RFI – DA202342470- Block 2 Section 58 Duffy

I am writing to respond to the entity comments received for the DA202342470 which proposes an Emergency Service Station at Block 2 Section 58 Duffy. The proposal consists of the construction of new single storey emergency services building, associated infrastructure, verge crossing, parking, upgrades to footpath, signage, landscaping and associated works.

TABLE 1: RESPONSES TO ENTITY COMMENTS

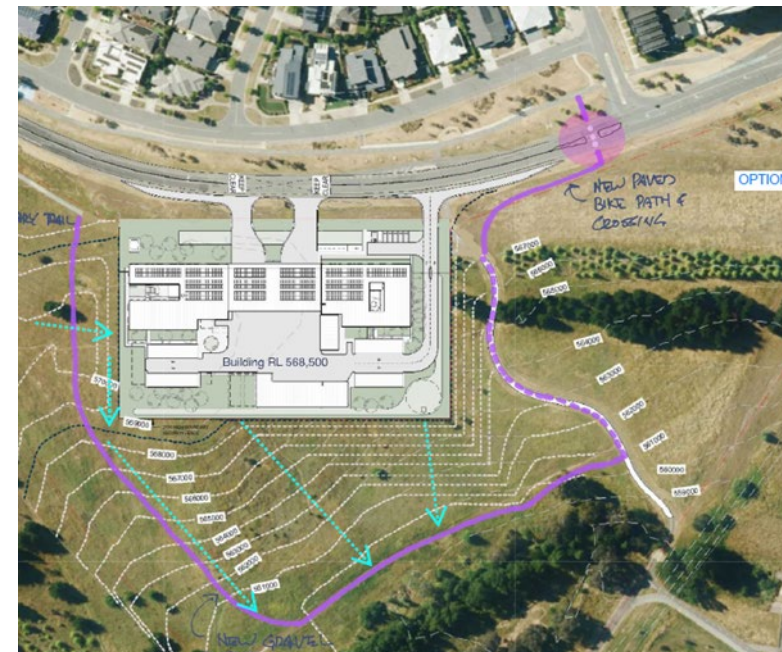
the CSTM and apply these growth factors to estimate the future background traffic.

Any upgrades to Cotter Road/John Gorton Drive/Harold White Avenue will be required regardless if the Project is constructed.
